361, 371, 391 Plummer Street (Cnr. Salmon Street), Port Melbourne

Application for Planning Scheme Amendment C182port

Appendix 1: Internal referral responses

Traffic Generation

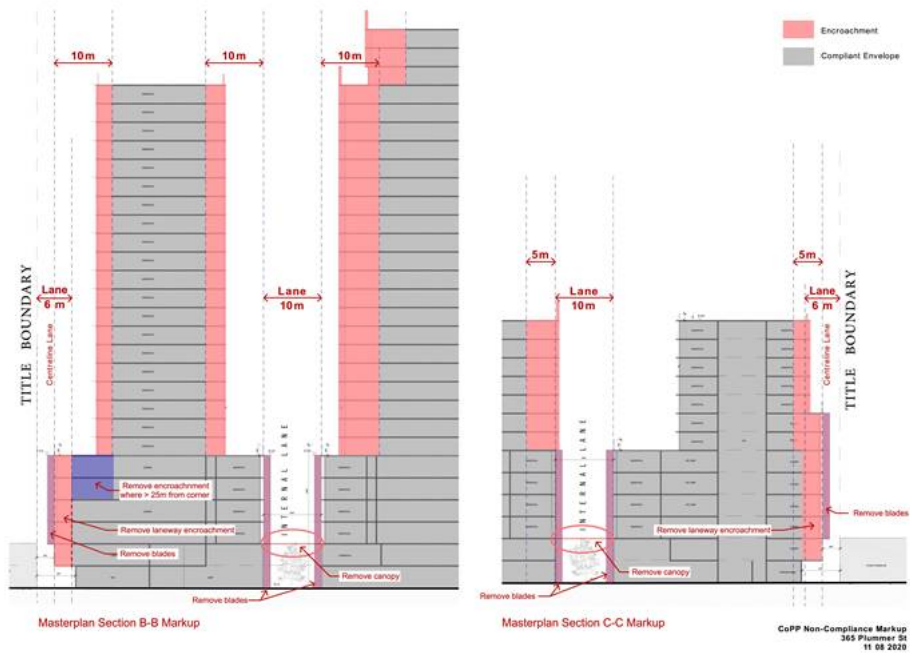
- Update traffic generation assessment to reflect the revised number of car parking proposed.
- I note Jacob's previous comments noted the traffic assessment was generally considered acceptable.
- **Please note that no cumulative trip generation for other developments has been considered.**

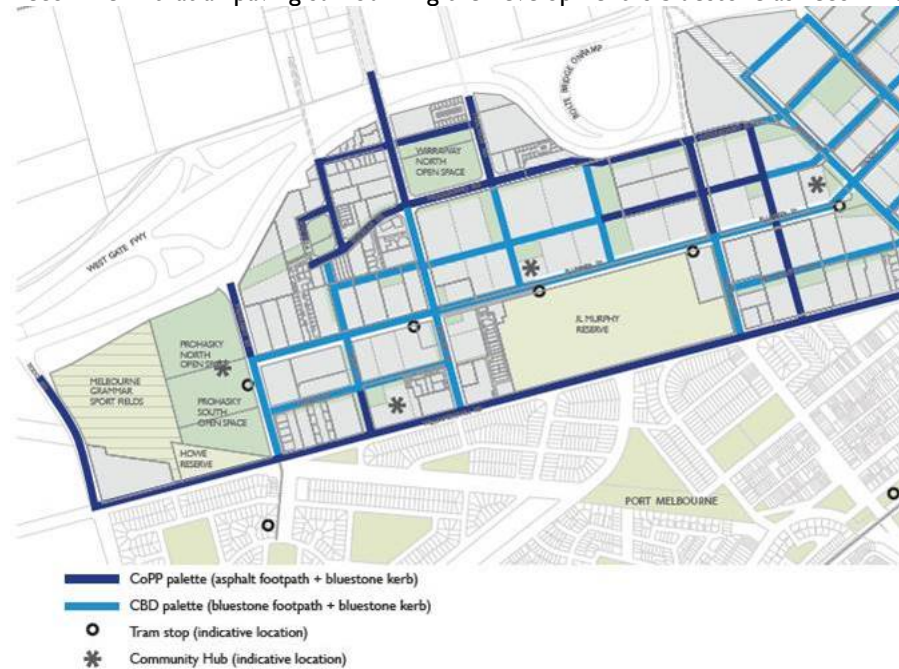
However the above statements are not reflected in the drawings as:

- The new public park is described on the landscape plan as “Final design subject to City of Port Phillip” implying that the developer is not delivering the public open space. Therefore this space should not count as being communal open space delivered by the development.
- There is only one new pedestrian laneway connecting Plummer Street to the new Street to the north.

- There is no ‘enhancement’ proposed to Plummer Street by the developer and no “upgrades’ are proposed on the drawings to Plummer Street. It appears that new street trees are being proposed by the developer on Salmon St.

Level 6 podium

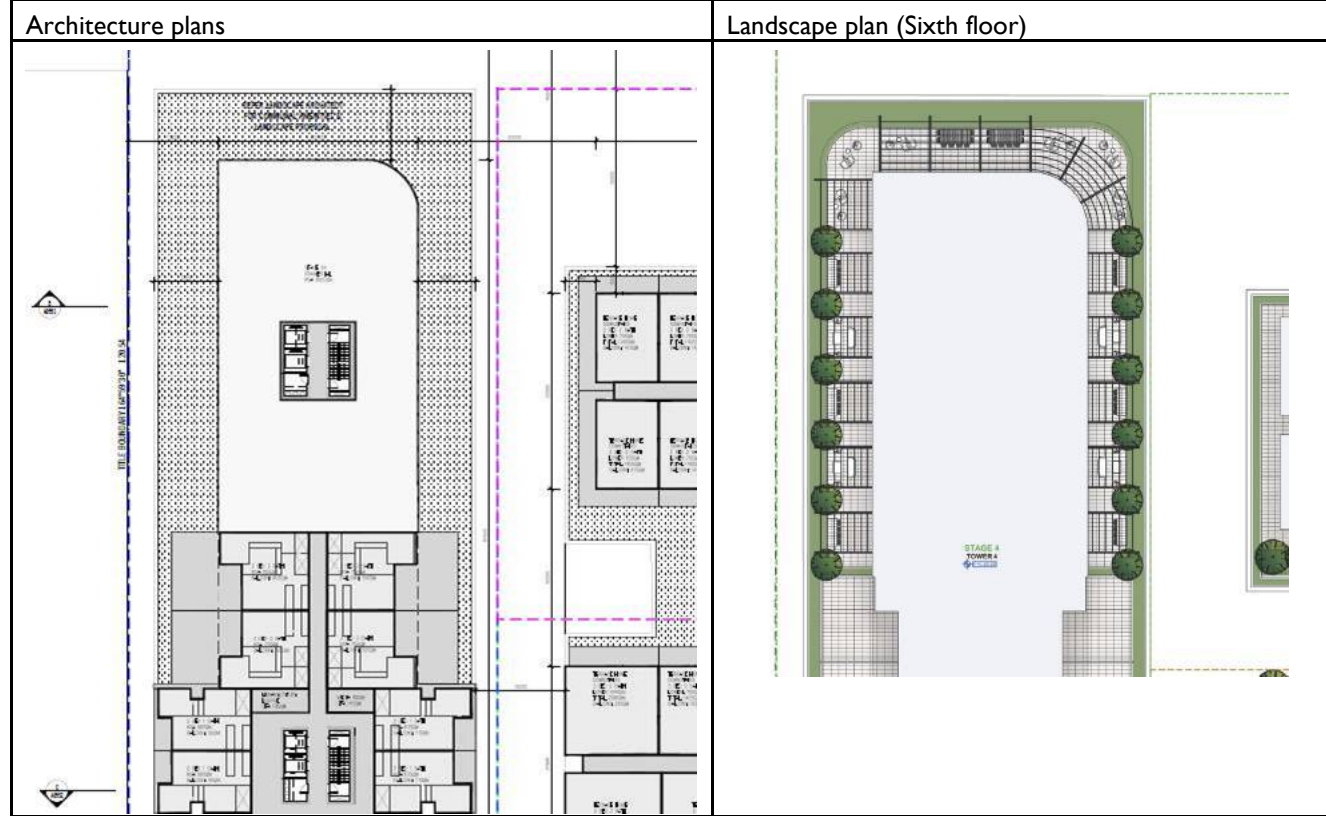
- People on the podiums should be able to overlook the ground floor uses. Current proposals show a wide area of buffer planting (green colour) which would prevent this
- Synthetic turf is not supported due to it’s contribution to the urban heat island effect. If green space is being proposed please employ real plants
- Please provide more information on these drawings. Lack of detail makes it difficult to understand. Please include building uses

- There are four proposed lawn areas being proposed on the level six podium. Communal open space should provide opportunities for recreational activities not just passive ones.
- It's unclear whether residents of tower 4 will be able to access any outdoor spaces on level 6 podium level. At the moment no amenities are provided – communal open space should support recreation, not just passive recreation.
